Value Engineering Report

Ordot Dump Closure, Guam

December 2005

This Value Engineering (VE) Report summarizes the VE Study conducted by Value Management Strategies, Inc., October 24–28, 2005, for the Guam Department of Public works (DPW). The subject of the study was the 100% design submittal Closure Plan and Post-Closure Plan for the closure of the Ordot Dump, Guam.

SKETCHES Ordot Dump Closure

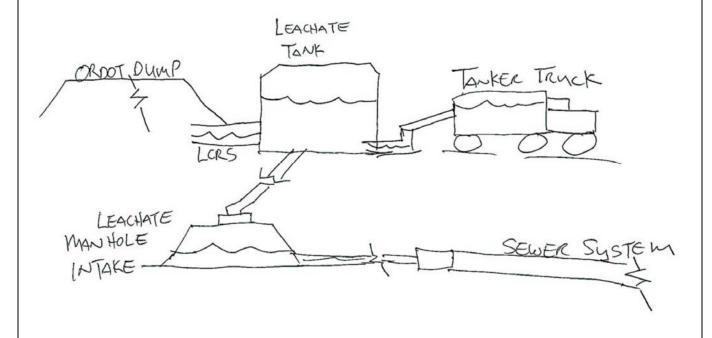
The justification for the concept of constructing a piping system for the leachate from the Ordot Dump centered on finding a more cost-effective and environmentally acceptable means, other than trucking over public highways. The cost issues focused on trucking equipment, operations and maintenance, and their availability—meaning having an ample number of trucks with enough capacity for the daily haul. The need to transport the leachate without having large numbers of trucks constantly traveling the highways loaded with waste liquids was also a driving point to use piping. The potential for spills and accidents further exposing the leachate to the public needed to be minimized.

If a piping system is installed, then the initial costs are incurred in the construction and then forgotten. There may be periodic maintenance cleanout.

TITLE: Eliminate Leachate Drainage Layer (Geocomposite) on Top Deck

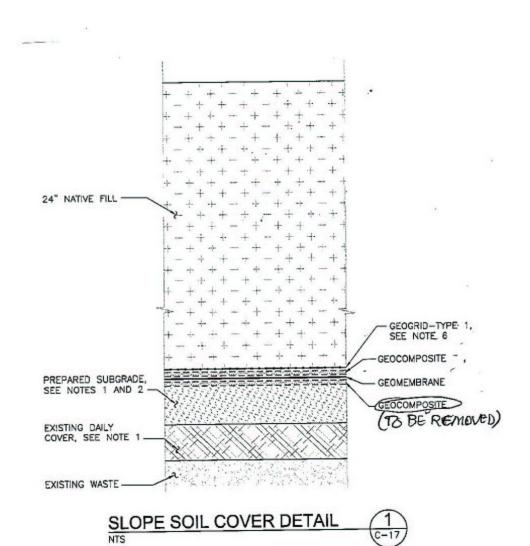
This particular detail does not appear to provide additional value to the design at the top deck elevation. There are several reasons that support the removal of the geocomposite from underneath the geomembrane, as noted below. Keep in mind that the sole reason for the installation of a geocomposite is to wick away/transport fluids, such as leachate or water, to a collection point(s).

No liquids will migrate from above the geomembrane into the geocomposite located below the geomembrane (geomembrane is blocking flow through it); therefore, the geocomposite below the

The alternative design calls for the removal of the second geomembrane that lies just beneath the geomembrane on the top deck. There is no other change to the original design within this detail.

SKETCHES

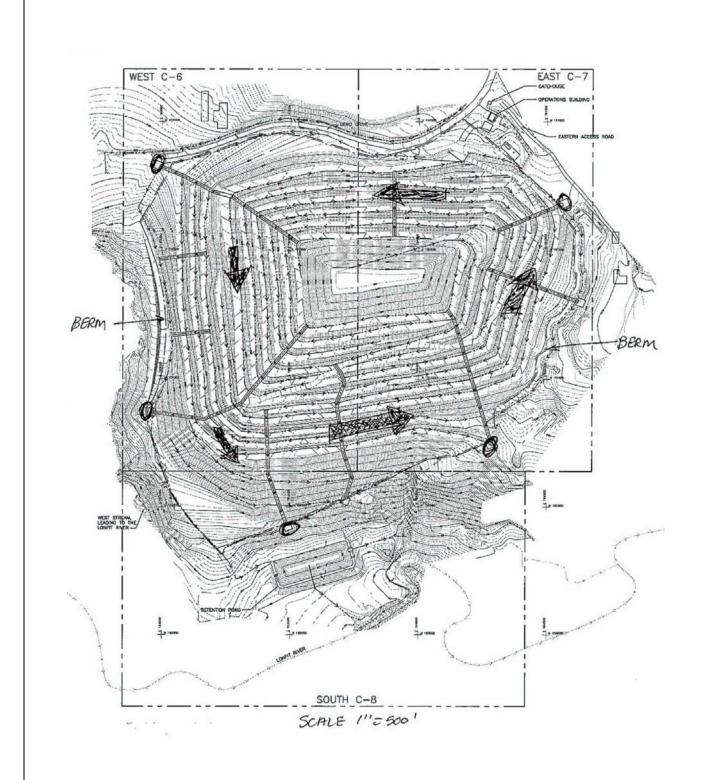
The cost savings for this project is significant if the "Berms" line item (from design Pre-Final Cost Estimate – Line 45), consisting of 4,630 lf is removed. Based on the supporting calculations, it appears that the "Berms" cost of \$1.5 million is for large ditches to convey water to the large detention pond.

See the initial sketch of this issue.

The alternative design calls for the hydroseeding of the slopes and benches, with seeds and a tactifying agent early on in the construction process. This is expected to eliminate the detention pond at the south edge of the site. Smaller and more accessible ponds at various points around the site can handle any sediment from bench run-off, although it is anticipated that any sediment would be nil after the vegetative cover matures. See the sketch for the alternative design change.

SKETCHES Ordot Dump Closure Use Prescribed Cover | Number | Page No. | | ED-1 | 3 of 6

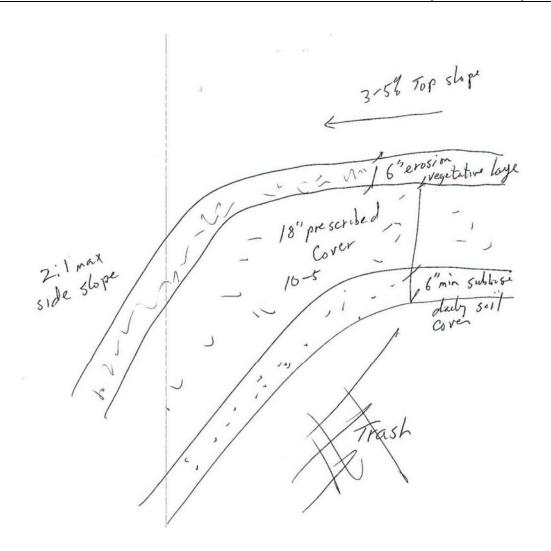
The prescribed cover is completely acceptable, in accordance with the regulations, for the Ordot Dump. This application appears feasible and should be given very serious consideration.

Provide an 80-mil HDPE cap to close the Ordot Dump waste mass.

| | SKETCHES Ordot Dump Closure | VMS ** | | |
|--------|--|--------|----------|--|
| TITLE: | (or Less as Appropriate) as in California | ED-2 | 3 of 6 | |

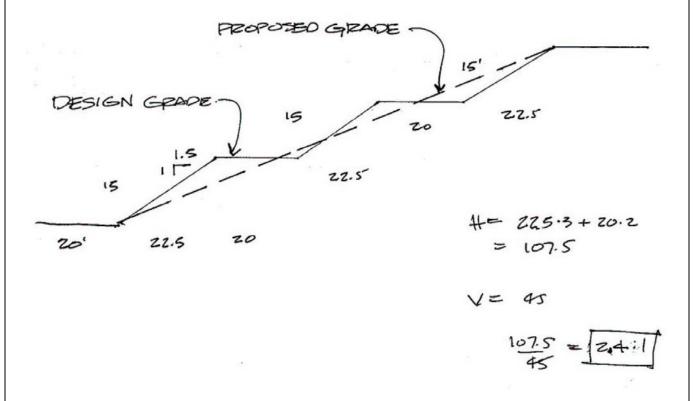
By flattening the side slopes, the barrier layer may be revised from the designed HDPE geomembrane and replaced with a soil layer. The benefits of a soil layer are significant with regard to both capital cost and long-term post-closure maintenance (see VE Alternative ED-1). The savings related to replacing the HDPE geomembrane with soil is included in VE Alternative ED-1.

The net effect of this change is to create a simpler, more efficient design, similar to that done for landfills in California, which further enhances the application of a Prescriptive Cover described in VE Alternative ED-1.

Change geometry of the side slopes to reflect a horizontal bench every 45 to 50 vertical feet. By doing so, the slope inclination between benches flattens from 1.5:1 to 2:1 (horizontal to vertical).

ED-5 & ED-6

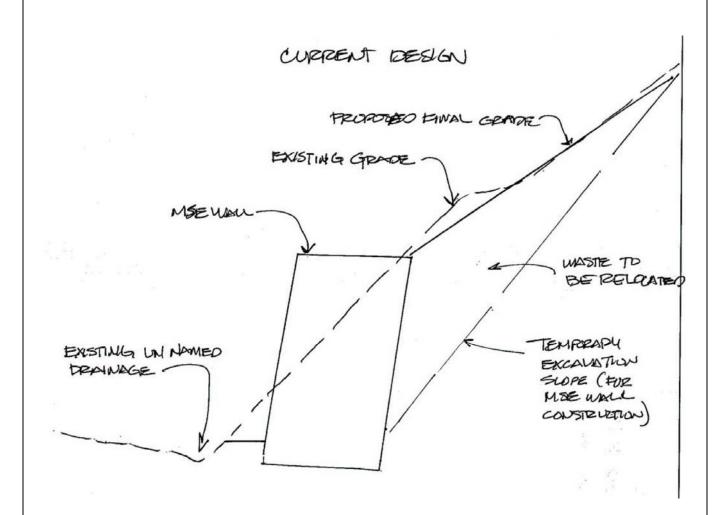
The un-named drainage meanders along the westerly edge of the dump. In one location, the drainage encroaches near the toe of the dump boundary. The proposed project is simply to straighten the drainage in the region where it meanders near the dump boundary. By straightening the drainage alignment, the ditch will be relocated approximately 80 to 100 feet west of its current location. Once the drainage has been relocated, an earthen embankment may be installed to support a portion of the westerly toe of the dump.

SKETCHES

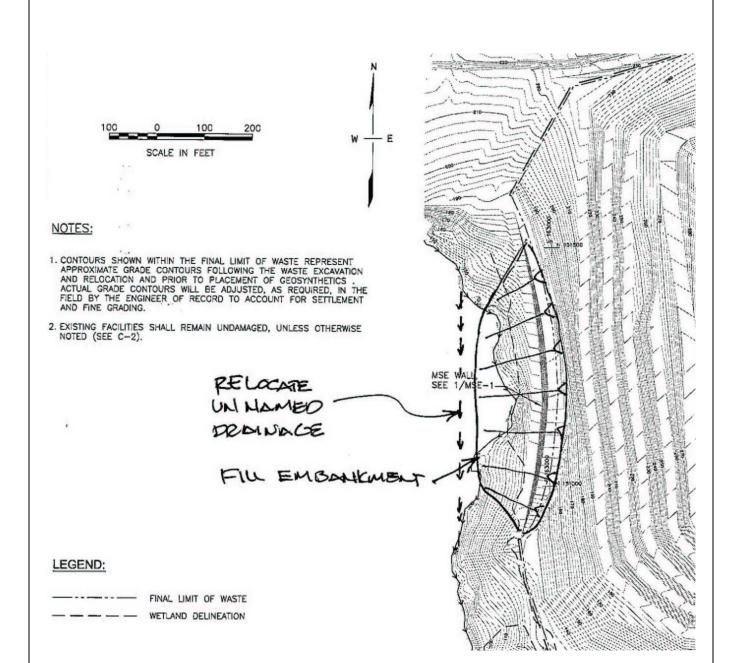
A 500-foot long section of the un-named ditch requires relocation. For planning purposes, a cost of \$200 per foot was used for the relocation cost.

TITLE: Convey No-Name Brook Through Culvert or Pipe

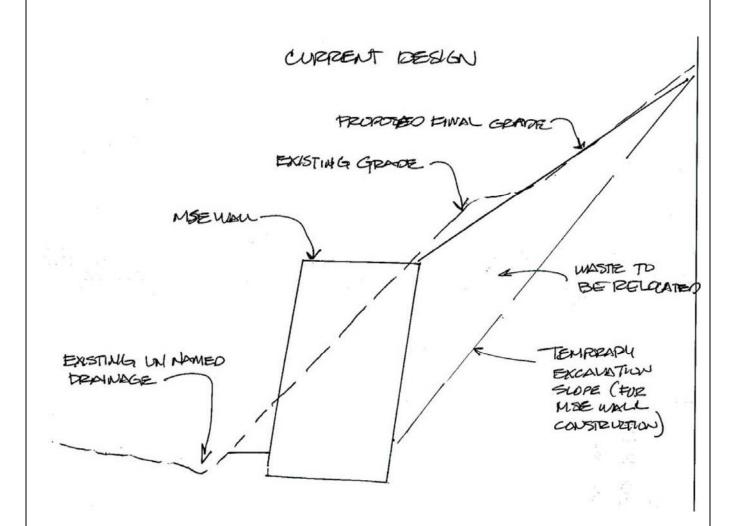
The un-named drainage meanders along the westerly edge of the dump. In one location, the drainage encroaches near the toe of the dump boundary. The proposed alternative is to direct the drainage in the region where it meanders near the dump boundary into a pipe or culvert, thereby conveying surface waters downstream. By placing a culvert in place of the existing drainage, fill materials may be placed over the existing drainage area. Once the culvert is installed, an earthen embankment may be installed to support a portion of the westerly toe of the dump.

A 500-foot long section of the un-named ditch requires a culvert. For planning purposes, a cost of \$100 per foot was used for the culvert cost.
